**Detroit
Edison**

Subject: Resolution of Certain Fire Protection Issues

Evaluation of Fire Door R3-13

FIGURE 1

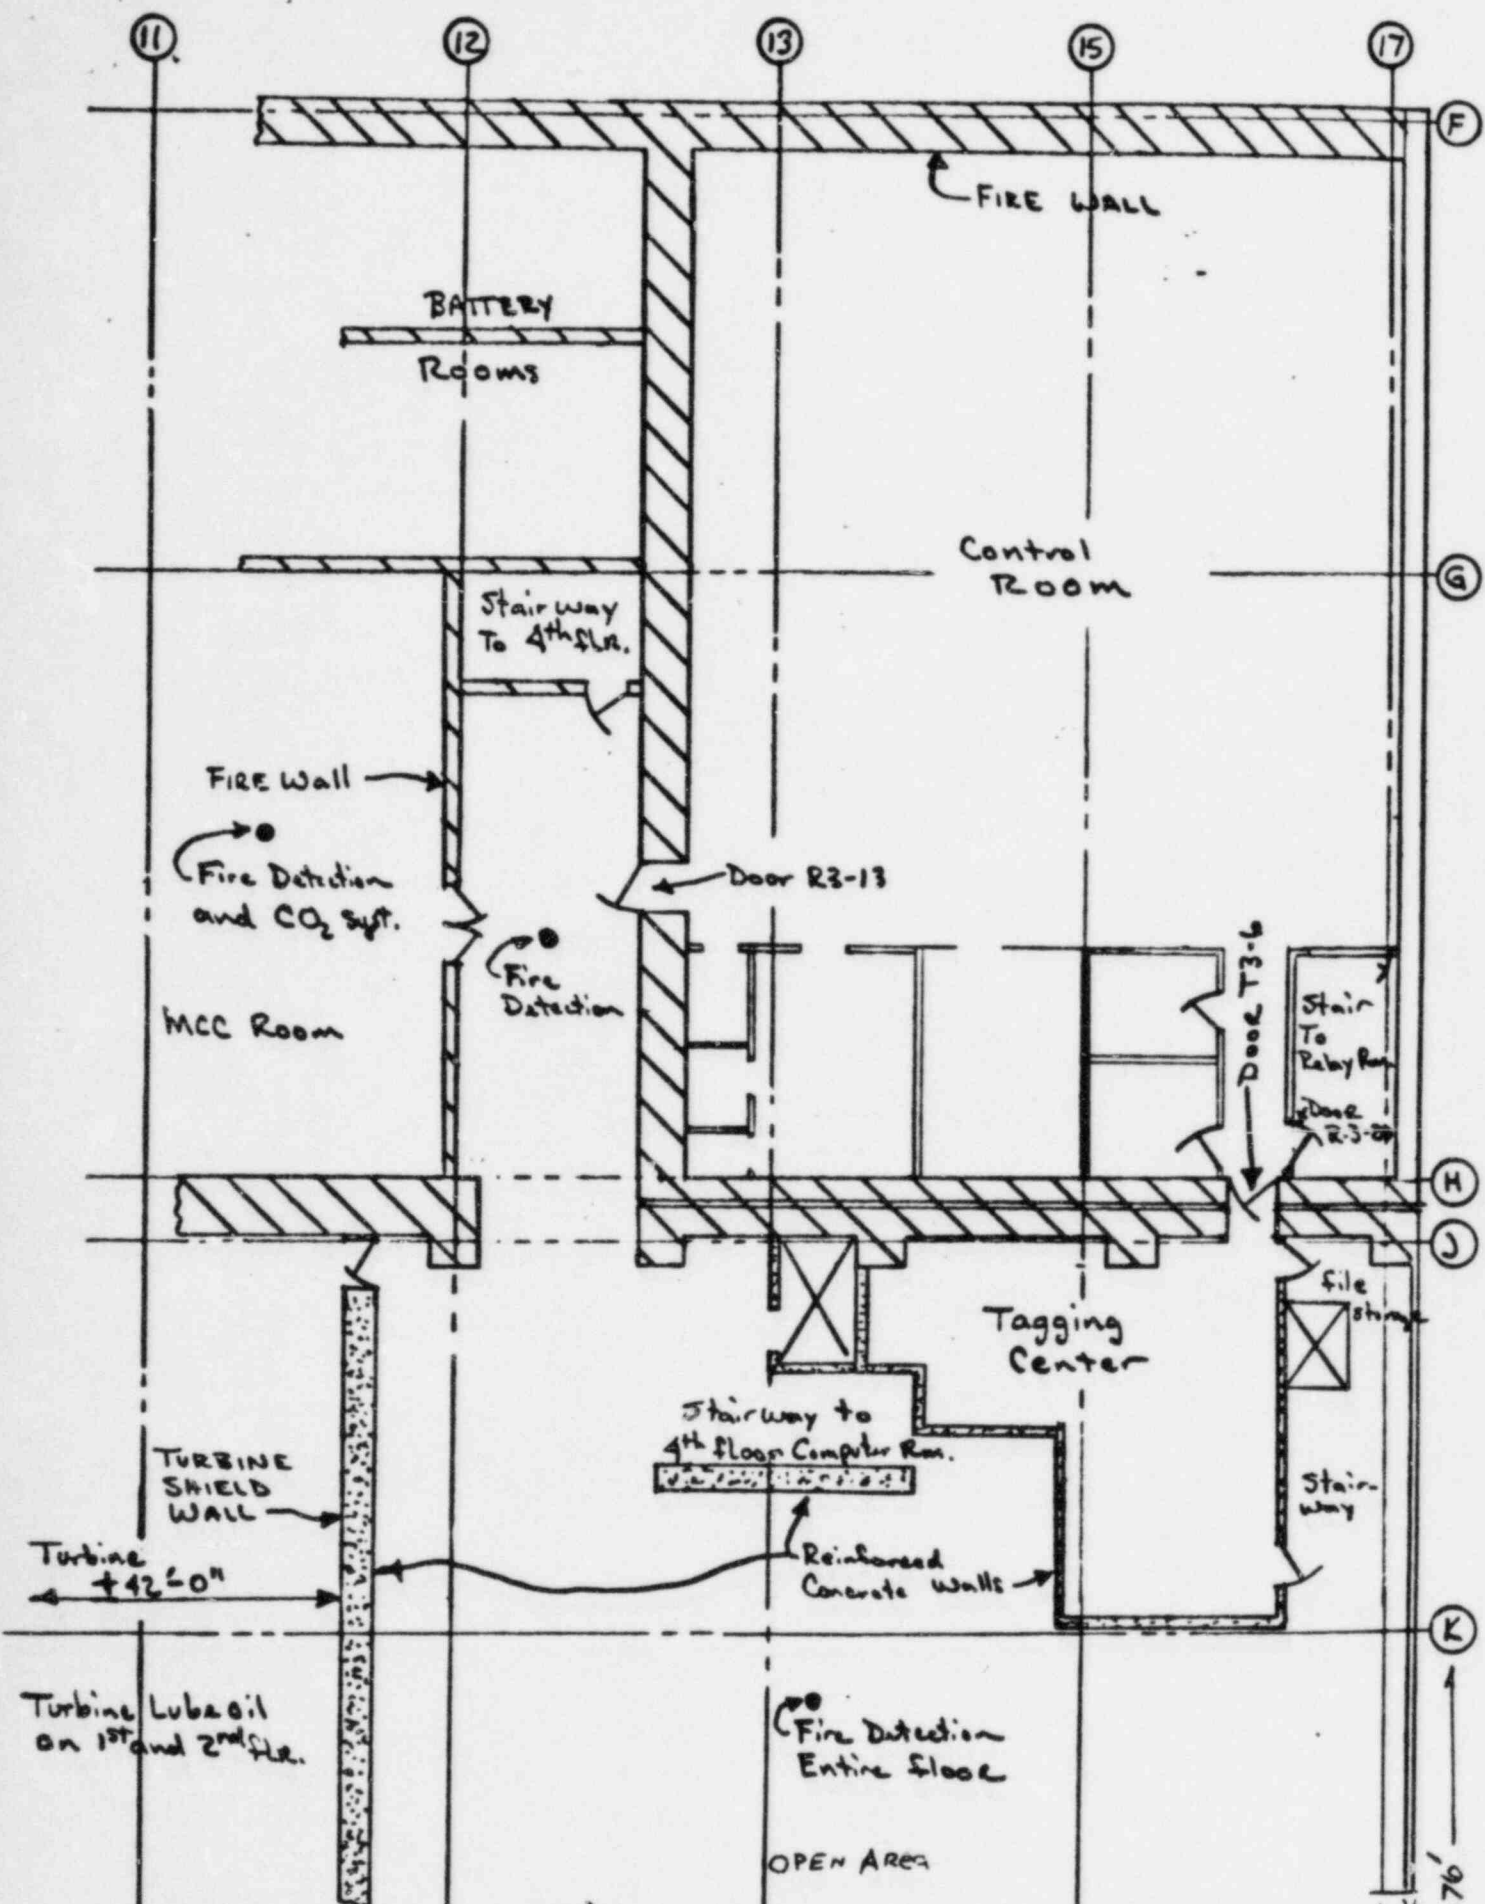
Test No. 2* was a 3 hour fire test for door R3-13 which has a transom, and is 3'8" wide which exceeds the width limits of listed doors by this manufacturer. This door met the conditions of acceptance of UL10B for a 1 1/2 hour rating.

Door R3-13 separates the control room from the Turbine Bldg. extension, floor elevation 643'-6". This security door is installed in a 3 hour fire resistance wall on the south side of the control room. This door is located approximately 25ft from the Turbine Building 3rd floor. (Refer to sketch No. 1).

Door R3-13 is considered adequate for its installation in a 2 hour rated fire wall assembly. Because the Turbine Building extension contains no fixed combustible material, and transient combustibles are maintained by administrative controls, a two hour assembly provides adequate protection.
